39T-09501/OZ-7638  
Nancy Pasato

<b>TO:</b>	<b>CHAIR AND MEMBERS PLANNING AND ENVIRONMENT COMMITTEE</b>
<b>FROM:</b>	<b>GEORGE KOTSIFAS, P.ENG. MANAGING DIRECTOR, DEVELOPMENT &amp; COMPLIANCE SERVICES AND CHIEF BUILDING OFFICIAL</b>
<b>SUBJECT:</b>	<b>APPLICATION BY: EXTRA REALTY 660 SUNNINGDALE ROAD EAST (NORTHWEST CORNER OF SUNNINGDALE ROAD EAST AND ADELAIDE STREET NORTH)  PUBLIC PARTICIPATION MEETING ON JULY 22, 2014</b>

The purpose of this report is to recommend a redlined draft plan of subdivision containing 23 low density blocks, 7 medium density blocks, 4 commercial blocks, 3 open space blocks, 2 park blocks, 6 walkway blocks, 1 stormwater management block, as well as several 0.3 m reserves and road widenings, all served by one new primary collector, 2 new secondary collectors, and 4 new local streets.

**Figure 7 – Staff redlined changes – Blocks 1-20 (single detached, street townhouses)**

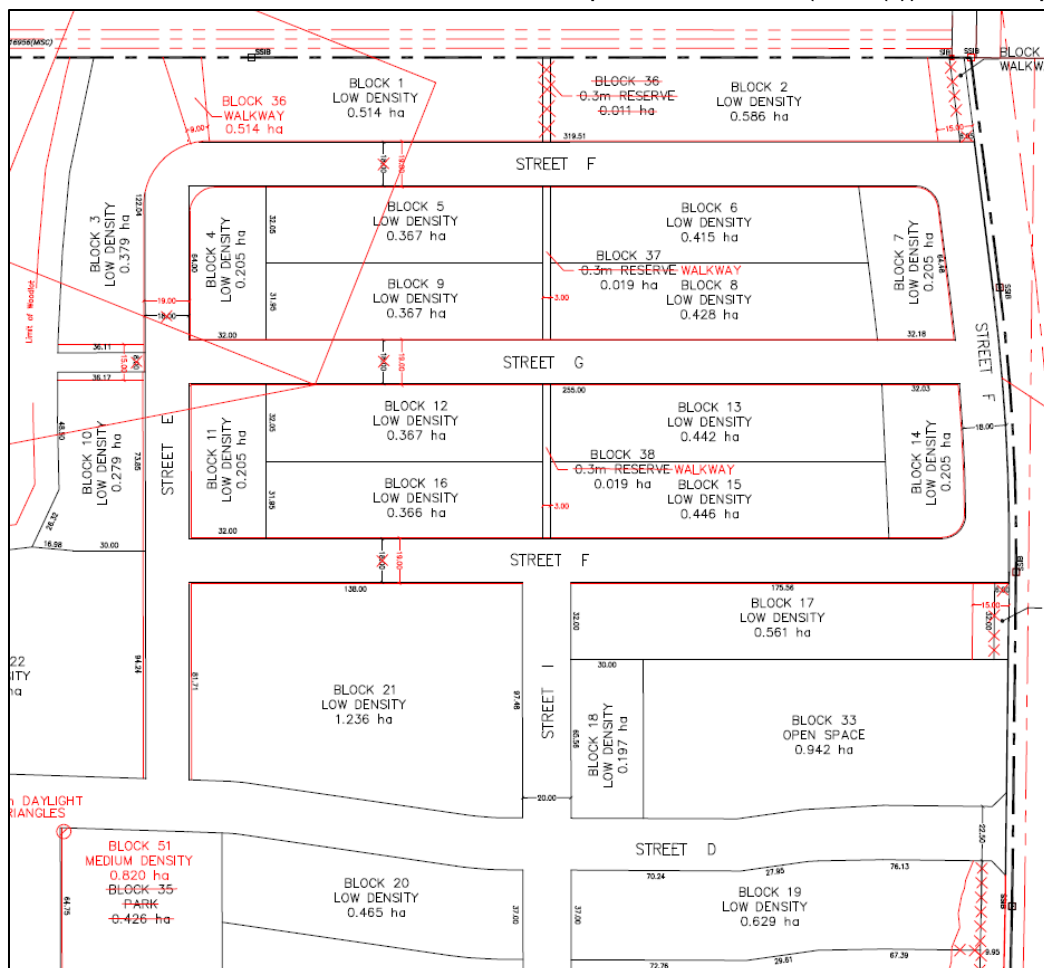
The Applicant had submitted 18 metre road widths through this section of the Plan. However, the standard road width for a local street is a minimum 19 metres and 20 metres for greater than 50 lots. Previous subdivision submissions included the use of rear laneways for the Blocks, which could warrant the reduction in street width to 18 metres, however, rear lanes are no longer proposed through this Plan; therefore the Plan will be redlined to include 19 and 20 metre road allowances. The window street, however, will continue to be 18 metres, as 18 metres is the standard for window streets in the City.

- Blocks 1-17 will be redlined slightly to account for changes in street widths.
- In order to avoid issues with small lots, zoning is recommended for Blocks 1-3, 5-6, 8-9, 12-13, 15-20 to be changed to Residential R1 (R1-4(\*)) Special Provision Zone and an Residential R1 (R1-5(\*)) Special Provision Zone to single detached dwellings with a lot area of 360 m<sup>2</sup> (R1-4) or 415 m<sup>2</sup> (R1-5) with 12 metre frontages, with special provisions for a reduced front yard setback of 3.0 metre to the house and 5.5 metre to the garage from a collector or local road, and a reduced interior side yard setback of 1.2 metres. An additional 20 m setback from the centerline of the high pressure oil pipeline (Sun Canadian) will be included as a special provision for Blocks 1, 2 and 3.

- In order to ensure variation in housing types, the “end” Blocks 4, 7, 11 and 14 are recommended to have the Residential R4 Special Provision (R4-2(\*)) Zone to permit

**Figure 8 – Staff redlined changes – Blocks 21-23 (cluster housing)**

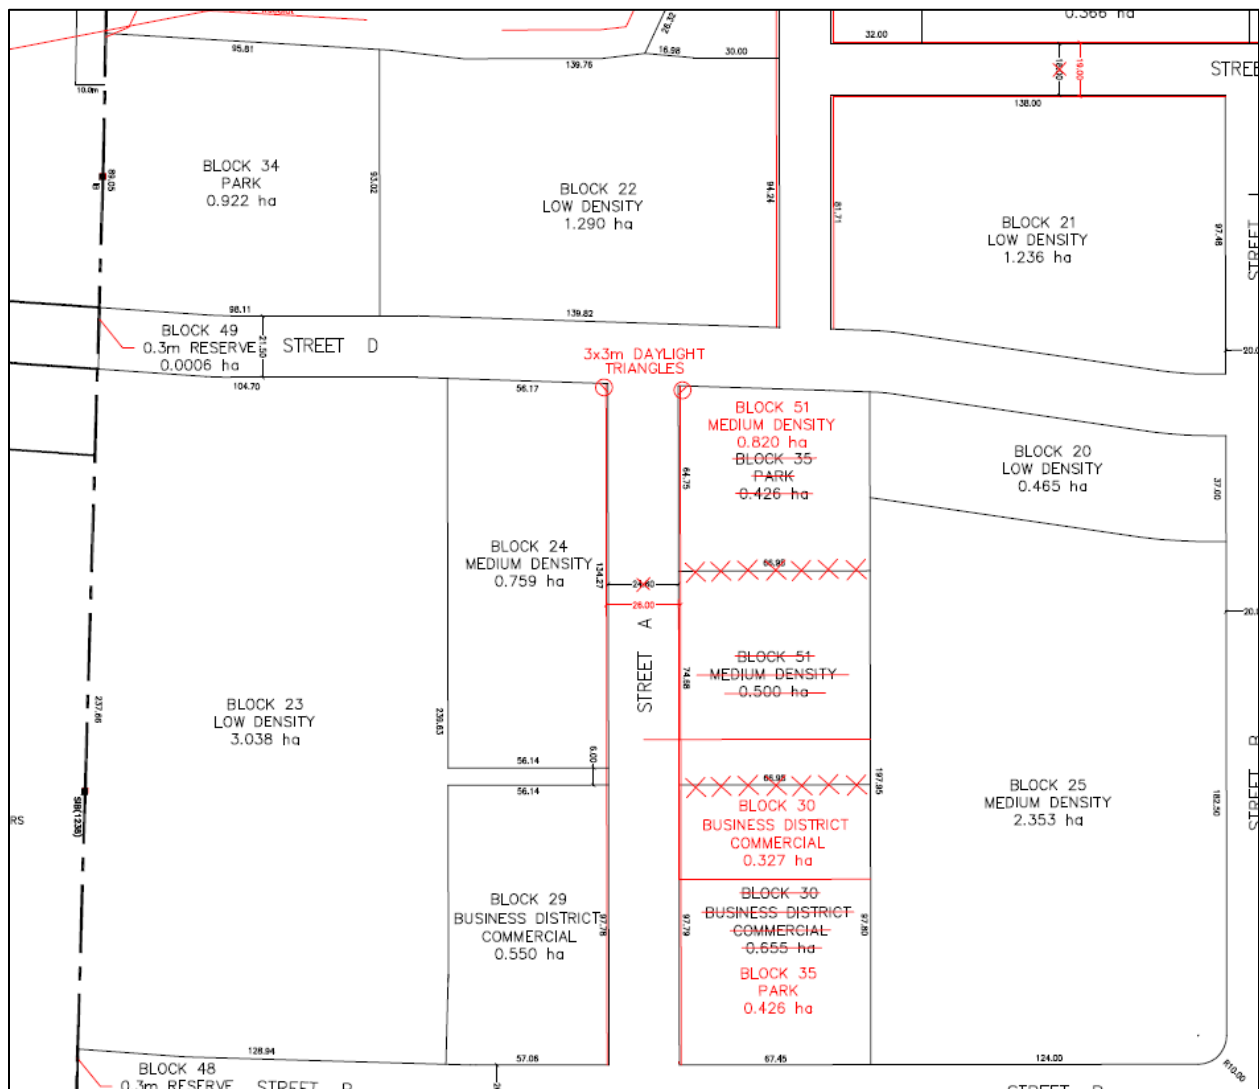
The proposed zoning for the Low Density Blocks provides for a range of cluster housing, including cluster single detached, semi-detached or duplex dwellings, and townhouse and stacked townhouse dwellings, at a maximum density of 30 units per hectare. This zone is consistent with the Low Density Residential designation. Special provisions are also recommended as per the original application, for a reduced front yard setback of 3.0 metre to the house and 5.5 metre to the garage from a collector or local road. This special provision will ensure any development, even cluster development, orient towards the street and create a strong street presence. The Applicant also asked for a specific 6.0 metre lot frontage for Block 23, as a small 6.0 metre piece of the block fronts onto Street A. This is intended as a pedestrian connection for the Block to Street A. Staff are recommending a special provision that states that notwithstanding the provisions of the Zoning By-law, frontage for this block will be along the secondary collector road (Street D).

- No redline changes to any of the Blocks.
- Zoning recommendation is Residential R5 Special Provision (R5-2(\*))/Residential R6 Special Provision (R6-4(\*)) Zone for Blocks 21-22 – the R5 Zone would permit cluster townhouses and stacked townhouses at a maximum height of 12 m and the R6 Zone would permit cluster single detached, semi-detached or duplex dwellings at a height of 10.5 m and a maximum density of 30 units per hectare.
- A Residential R5 Special Provision (R5-2(\*\*))/Residential R6 Special Provision (R6-4(\*\*)) Zone is recommended for Block 23, with the same special provision as the above, with an additional special provision to recognize that notwithstanding the provisions of the Zoning By-law, frontage for this block will be along the secondary collector road (Street D).

**Figure 9 – Staff redlined changes – Blocks 24-28, 51, 54 (cluster housing)**

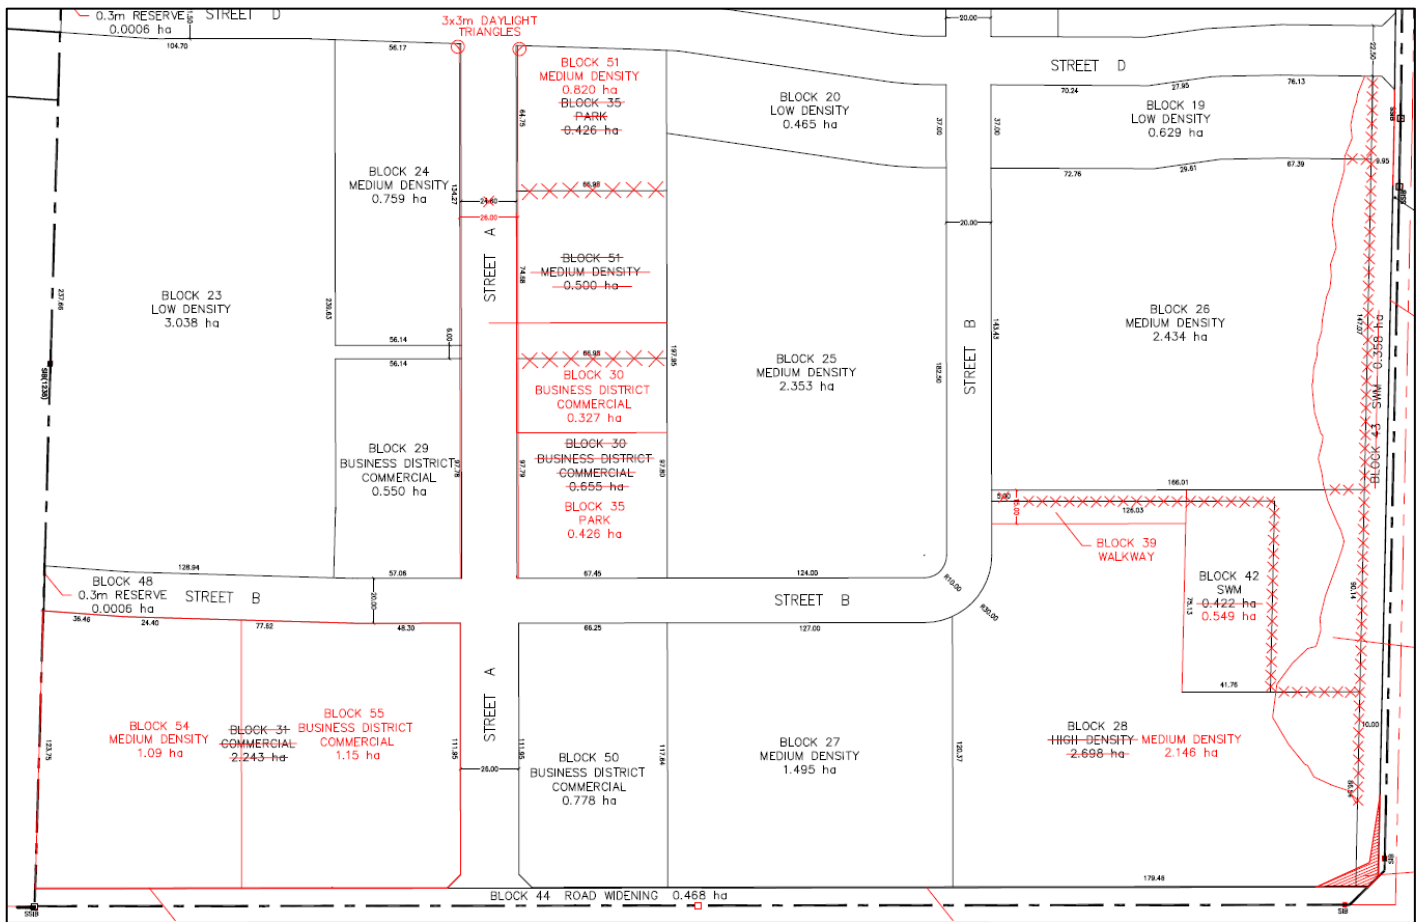
lands within the conveyance block (Block 43) to be included in the Residential Block for the purposes of calculating lot area, density, lot coverage, and landscape open space, and have also requested a reduced rear yard setback adjacent to the conveyance block. The Applicant has indicated that the 15 m setback from the centre of the stream more than protects the feature, and that an additional 8 m rear yard setback would further sterilize the reduced amount of developable land within Blocks 26 and 28. Staff agree with the Applicant and are recommending these special provisions for Blocks 26 and 28.

- Refusal of High Density Residential for Block 28.
- Redline Block 28 to Medium Density, with an implementing zoning of Residential R5 Special Provision (R5-4(\*))/Residential R6 Special Provision (R6-5(\*))/Residential R8 Special Provision (R8-4(\*)) Zone – see Medium Density Blocks 24-28, 51, 54 for further detail (and Figure 1 for graphic).

**Figure 10 – Staff redlined changes – Blocks 29, 30, 31, 50 (commercial)**

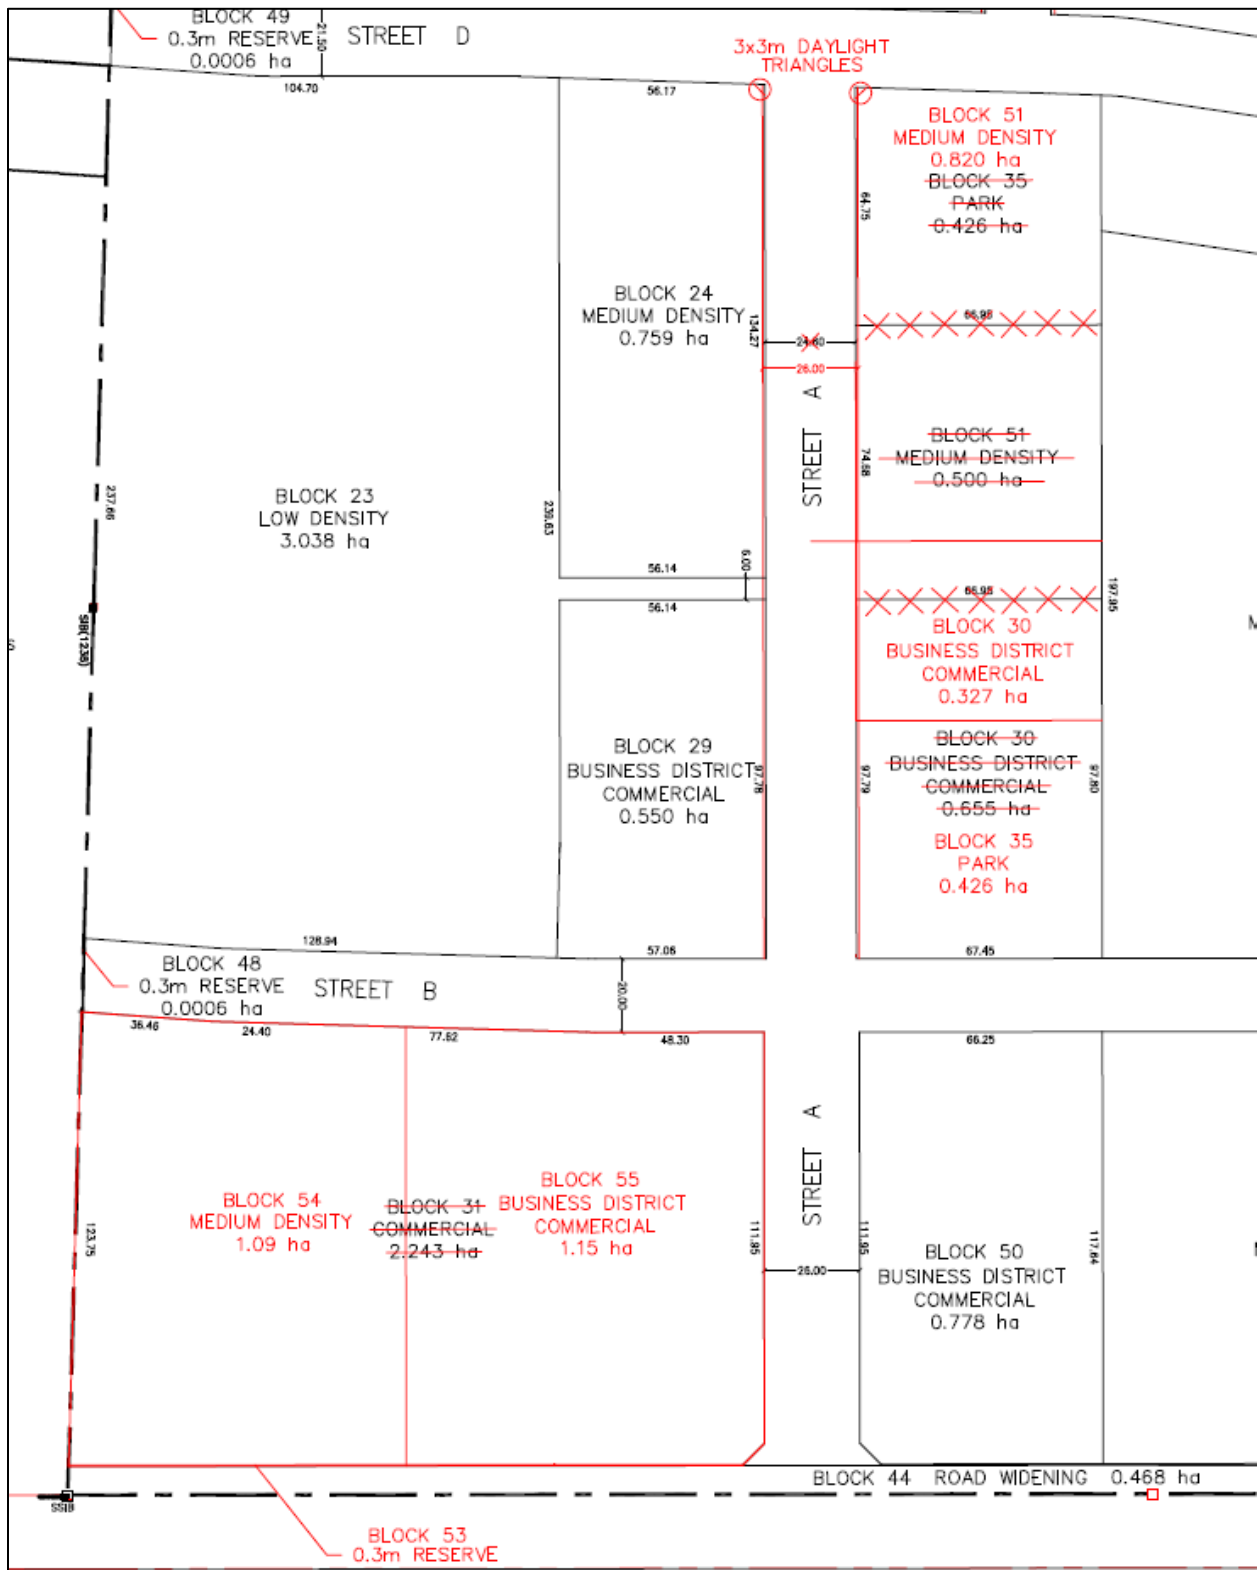
Overall, Staff's proposed zoning is an attempt to provide commercial opportunities within the subdivision, such as a small scale grocery store, while balancing the goal of a mixed use pedestrian oriented streetscape, and still maintain a smaller scale, so as not to detract from future commercial sites in the area, in keeping with the Uplands North Area Plan.

- Implementing zoning for Block 29 is a Business District Commercial Special Provision (BDC2(\*)•D75•H18) Zone, which permits a wide range of commercial uses on the first floor, with a maximum height of 18 m and a maximum density of 75 units per hectare (to be shown as D75•H18 on the zoning map only), with special provisions to require that the lot frontage for the Block is considered to be along the primary collector, to require the commercial/retail/office uses on the ground floor to have the primary entrance for individual tenants oriented toward the primary collector, for a minimum 2 m and maximum 4 m front and exterior side yard setback, and to require a mixed use building, with 500 m<sup>2</sup> maximum retail/office/commercial floor area limited to the first floor and residential units above.

- Redline Block 30 by moving it to the north of the redline Park Block (Block 35) and to the south of Medium Density Block 51, and reducing the size of the Block from 0.66 ha to 0.33 ha. Implementing zoning for Block 30 is a Business District Commercial Special Provision (BDC2(\*\*)•D75•H18) Zone to permit a wide range of commercial uses on the first floor, with a maximum height of 18 m and a maximum density of 75 units per hectare, with special provisions to require the commercial/retail/office uses on the ground floor, to have the primary entrance for individual tenants oriented toward the primary collector, for a minimum 2 m and maximum 4 m front and exterior side yard setback, and to require a mixed use building, with 250 m<sup>2</sup> maximum retail/office/commercial floor area limited to the first floor and residential units above.

**Figure 13 – Staff redlined changes – Blocks 42-43 (SWM and conveyance)**

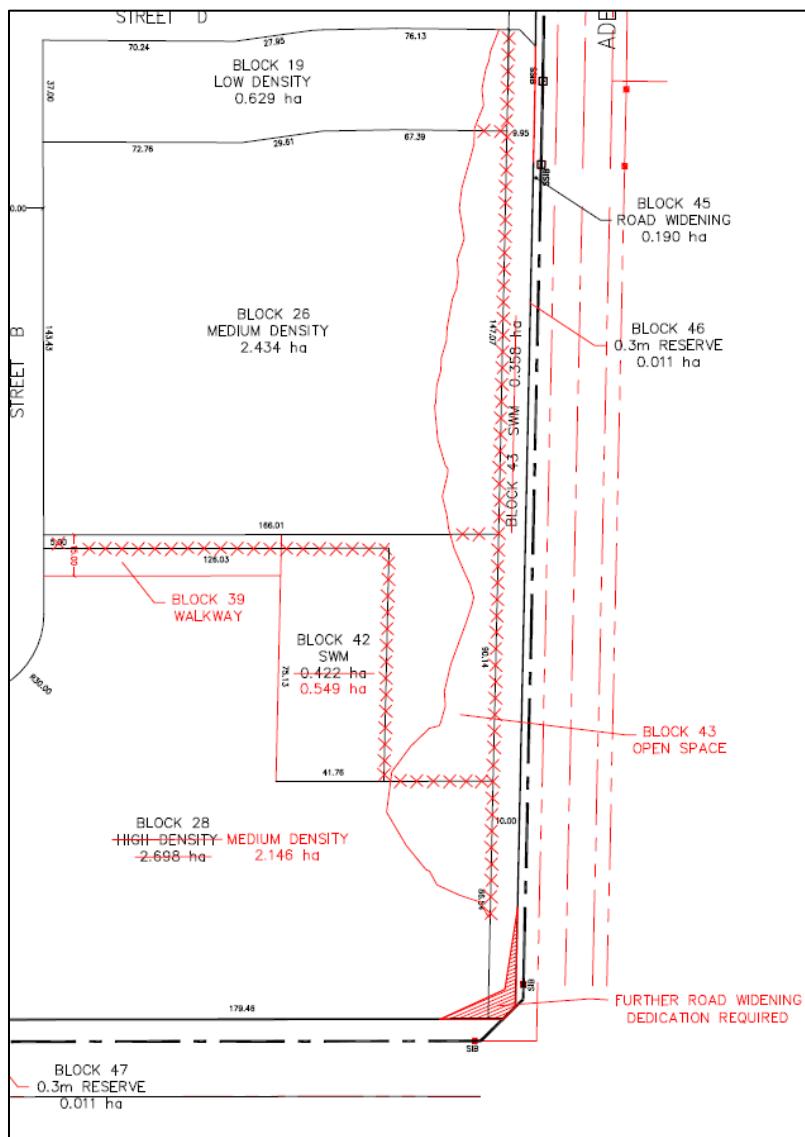
Based on comments received from the UTRCA, a redlined conveyance Block 43 was requested to reflect the stream meander and includes a 15 m setback from the stream edge. The conveyance channel falls within the UTRCA Regulation Limit, and as such, a permit is required for any works within this area, including the conveyance channel. The UTRCA has indicated they require that the watercourse be maintained in its current location and configuration, and consistent with our policies that a 15 metre setback be applied from the bank of this feature. Accordingly the block will need to be revised to accommodate this regulated feature and the required buffer. The Applicant had requested an Open Space (OS1) Zone for both blocks, however due to the change in the conveyance channel; Staff is recommending an Open Space Special Provision (OS4(\*)) Zone for Block 43. A special provision will be added to the OS4 Zone to permit the lands/area within the OS4 Zone to be used in the adjacent Residential Blocks (Block 26 and 28) for the purposes of calculating lot area, density, lot coverage, and landscape open space.

As a result of these changes to Block 43, Block 42 (SWM Block) will also be redlined to ensure no portion of the watercourse is located within the SWM Block. An Open Space (OS1) Zone will be applied to the SWM Block 42, as requested by the Applicant.
